RX2e

Technical Bulletin

Number	RX2e_TB_001	Date	02.08.2022
Revision	001	Issuer	QEV Technologies
Rear suspension rocker update

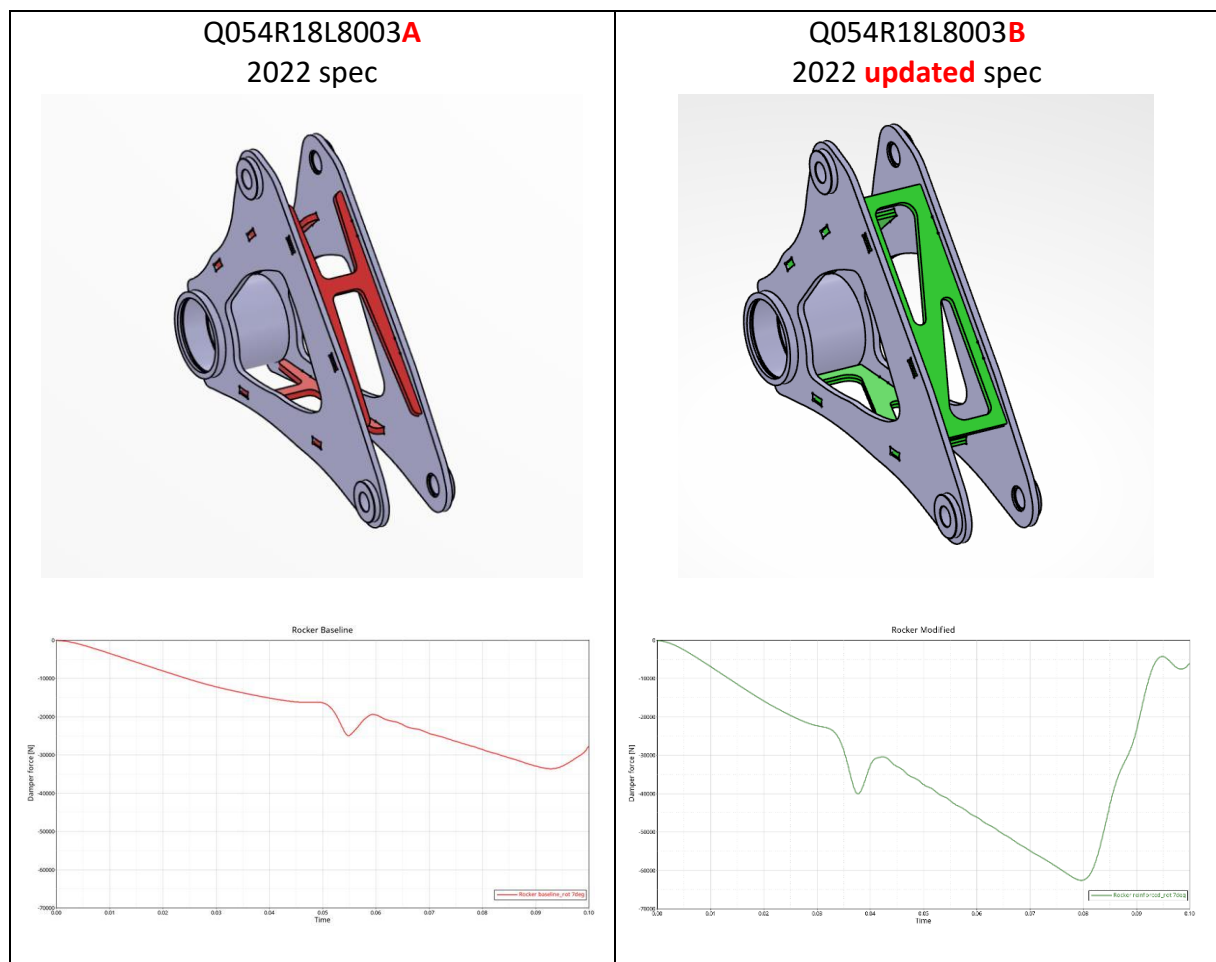
The rear rocker 2022 spec had some early failures at certain landing conditions on one tire. Due to that reason, an updated rear rocker has been designed and will be included in the catalogue and will be homologated in the RX2e class by 15th September 2022.

- New rocker is 25% stronger than the baseline at 0° angle between pushrod/rocker.
 - New rocker is 190% stronger than the baseline at 7° angle between pushrod/rocker.
- The usage of Q054R18L9001A (2021 rear rocker) will be authorized & homologated for all races from now and until new ref. Q054R18L8001B (2022 updated spec) starts to be sold.
